Subject: Use of Rumble Stripes on 2-foot Paved Shoulders

MISSISSIPPI DEPARTMENT OF TRANSPORTATION	
SPECIAL DESIGN: RUMBLE STRIPES (GROUND-IN)	
DATE	WORKING NUMBER
DESIGN TEAM <u>s.reeves</u> CHECKED	SHEET NUMBER
DATE <u>04/16/04</u>

Subject: New Construction Lane Width & NO RUMBLE STRIPS

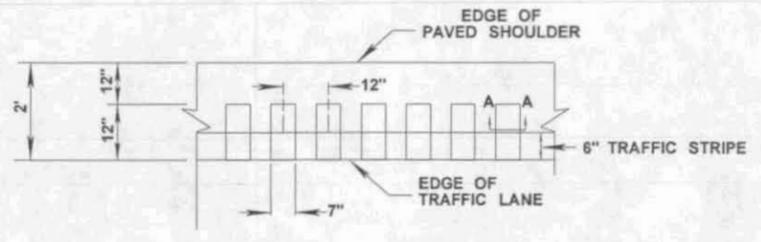
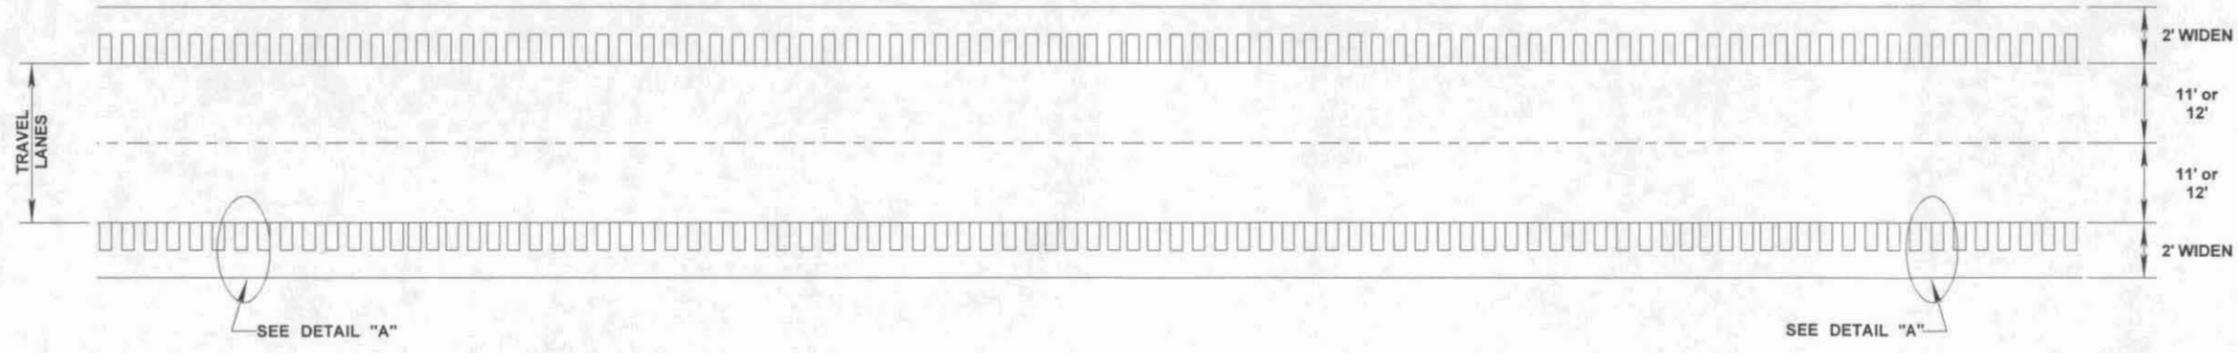
Attached is a Special Design Sheet for the use of rumble stripes on 2-foot paved shoulders. Notice the use of the term "stripes" and not "strips" due to the edge stripe being placed on the rumble strips.

This Special Design Sheet was developed for the Districts' use on their maintenance projects and not for projects being designed within Roadway Design Division; however, if a District request the use of rumble stripes on 2-foot paved shoulders be used on projects developed within Roadway Design Division, the District must request a design variance from the Chief Engineer and be approved before it can be included within the plan development.
